CAMPUS AREA NEIGHBORHOOD ASSOCIATION

Lake Street Garage Steering Committee Report

November 21st, 2022

Alternate Layout

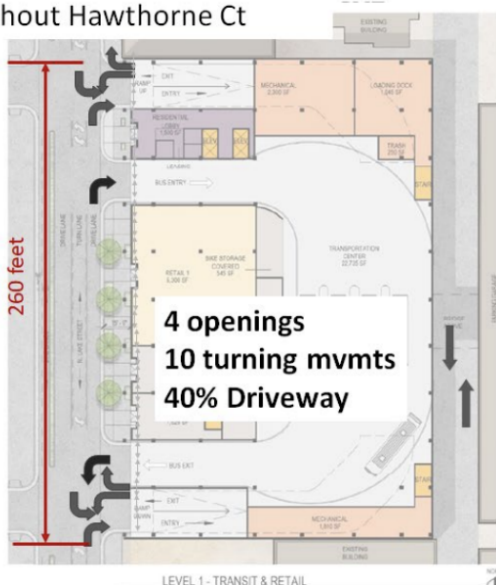
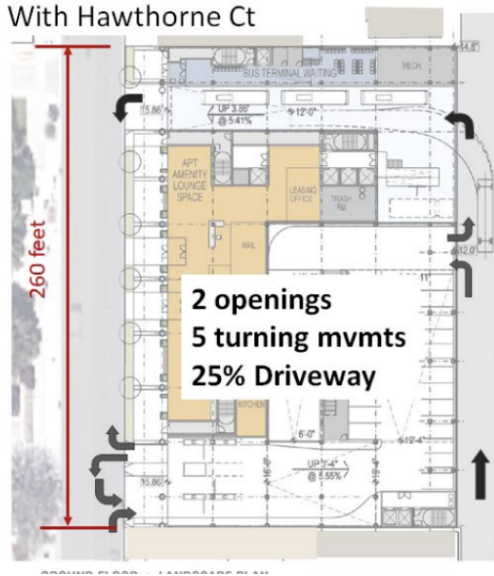
The traffic flow of the current proposal requires intercity buses to cross important, busy lanes of traffic that include **the Major BRT (Bus Rapid Transit) Lane, the unprotected Bike Lane, and the Major Sidewalk**. This is a major logistical flaw as this presents lots of opportunities for major backups on University Ave due to buses not being able to cross the lanes of traffic and a higher risk of accidents due to the Hawthorne Ct functioning as an alleyway and not being a controlled intersection. Not to mention University Ave is a much faster street than Lake Street and increases the risk of accidents like fender benders and bikers being hit during rush hour traffic. The development needs to use Lake Street for buses because it is a controlled intersection with a stoplight as compared to the Hawthorne Ct entrance which has no traffic signals. Additionally, the East Campus Mall BRT Spot can be inferred as a major bus stop for students commuting across campus. The three major residence halls are within a couple of blocks of this spot. Blockages at the Hawthorne Ct entrance will disrupt this major BRT system hub.

The three spots for buses seem inadequate and are shortchanging the intercity bus station potential. The bus terminal ought to have five bays like the old bus terminal and there needs to be a better plan for staging. They are trying to do too much at once and seem to be modeled after La Crosse without consideration of the unique challenges of this area. The Bus terminal is different and you can drive straight through it. This design

seems too complex at the moment. The proposal does not seem to completely address everything. The entrances for residential parking are on the same side as the Van Galder Bus entrance. This mix of traffic seems problematic with bus schedules and the residential experience. If there is a queue that wraps around the corner, this will affect the BRT lane and Metro Bus lane. There is also a need for more entrances and exits to accommodate queues during special events.

The alternative layout provided by the City of Madison Transportation Department

- Moving the entrances to the bus terminal and parking to Lake Street
- Creating a Transportation plan that considers all modes of transportation on the site
- Using this project to activate Hawthorne Court with public art, lighting, and cameras
- Make the bus terminal part of a covered part of Lake Street.
- We need a complete Traffic/Environmental Study that considers the impact on local businesses, existing apartments, and all current modes of traffic circulating through this site.
